PERMIT NUMBER: NYR11I563

INSPECTION REPORT #127

Baker Rd/Dunlap Ave/ South Street Rd, Marcellus Location

10:17 AM UNITED States Longitude -76.3415° W 76°20'29"W WEDNESDAY, 27 DEC LATITUDE 42.9744° N 42°58'27"N

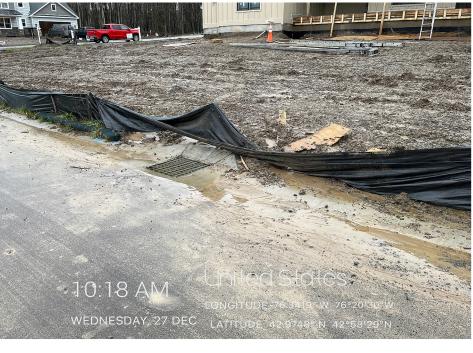
Repair damaged silt fence along Baker Road (lots 5-7)

Repair silt fence where damaged and allowing sediment laden water to run into catch basin
